# HISTORIC AND DESIGN REVIEW COMMISSION

**HDRC CASE NO:** 2017-397  
**ADDRESS:** 415 WILLOW  
**LEGAL DESCRIPTION:** NCB 1653 BLK A LOT N 55 FT OF 17 & 18  
**ZONING:** R-5, H  
**CITY COUNCIL DIST.:** 2  
**DISTRICT:** Dignowity Hill Historic District  
**APPLICANT:** Eduardo Villalon  
**OWNER:** Eduardo Villalon  
**TYPE OF WORK:** Construction of a two story, single family residential structure  
**APPLICATION RECEIVED:** June 29, 2018  
**60-DAY REVIEW:** August 28, 2018  
**REQUEST:**

The applicant is requesting a Certificate of Appropriateness for approval to construct a two story, single family residential structure on the vacant lot at 415 Willow in the Dignowity Hill Historic District.

REAR ELEVATION  
SCALE: 1/4" = 1' - 0"

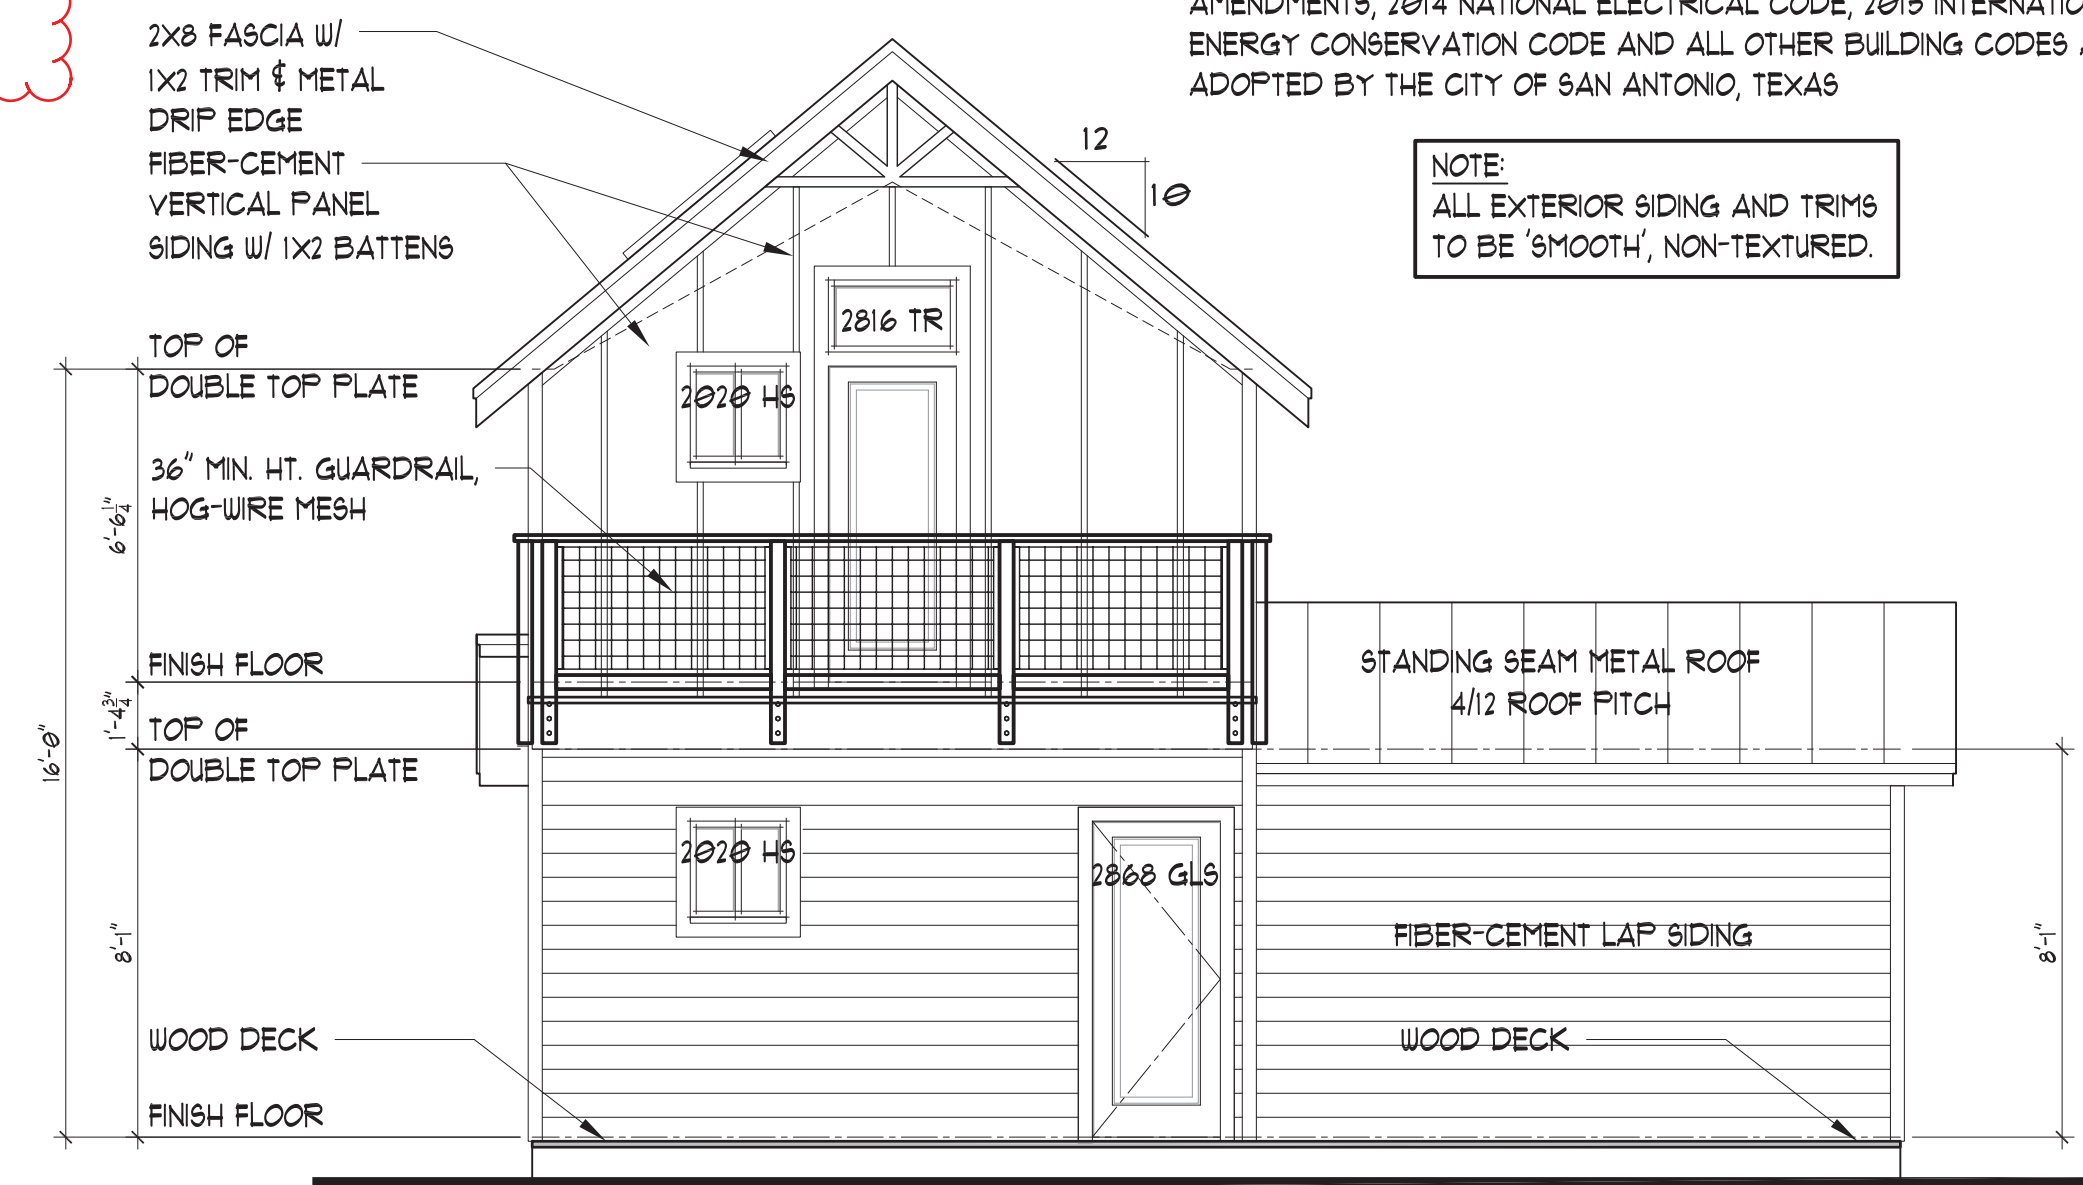
- e. **SCALE & MASS** – Per the Guidelines for New Construction 2.A.i., a height and massing similar to historic structures in the vicinity of the proposed new construction should be used. In residential districts, the height and scale of new construction should not greatly exceed the historic precedent. Each of the three historic structures that are oriented toward Willow as well as the majority in the immediate vicinity feature heights of one story. The applicant has noted a top plate height of 16' – 0" with an approximate seven (7) feet of height from the top plate to the ridge line for an overall height of approximately twenty-three (23) feet. Houses in the immediate vicinity feature one story in height. The applicant has proposed a second story that features reduced massing and a vaulted ceiling to reduce the overall height. Staff still finds that the overall height should be reduced through the shortening of the second story or the lowering of the top plate height to produce an overall height that is comparable with the heights of neighboring, historic structures."

- h. WINDOW & DOOR OPENINGS – Per the Guidelines for New Construction 2.C.i., window and door openings with similar proportions of wall to window space as typical with nearby historic facades should be incorporated into new construction. The applicant has proposed window and door openings that are generally consistent with those found on historic structures in regards to location and size. Since conceptual approval, the applicant has added additional fenestration in the forms of both traditionally sized windows as well as contemporary windows. Staff finds that added fenestration is appropriate; however, their sizes and placements are not.

- k. ARCHITECTURAL DETAILS – New building should be designed to reflect their time while representing the historic context of the district. Additionally, architectural details should be complementary in nature and should not detract from nearby historic structures. While the applicant has incorporated many design elements that are found throughout the Dignowity Hill Historic District, staff finds that the proposed window shutters should be eliminated as they are not found historically in the district.

- i. That the applicant reduce the proposed height through the shortening of the second story or the lowering of the top plate height to produce an overall height that is comparable with the heights of neighboring, historic

- v. That the proposed additional window fenestration be modified to feature windows that feature proportions to those found historically in the district. Windows should feature sashes. Small, fixed windows should not be used.

- vi. That the applicant eliminate the proposed window shutters.
- vii. That the applicant submit a detailed column design noting a width of six inches square and capital and base trim.
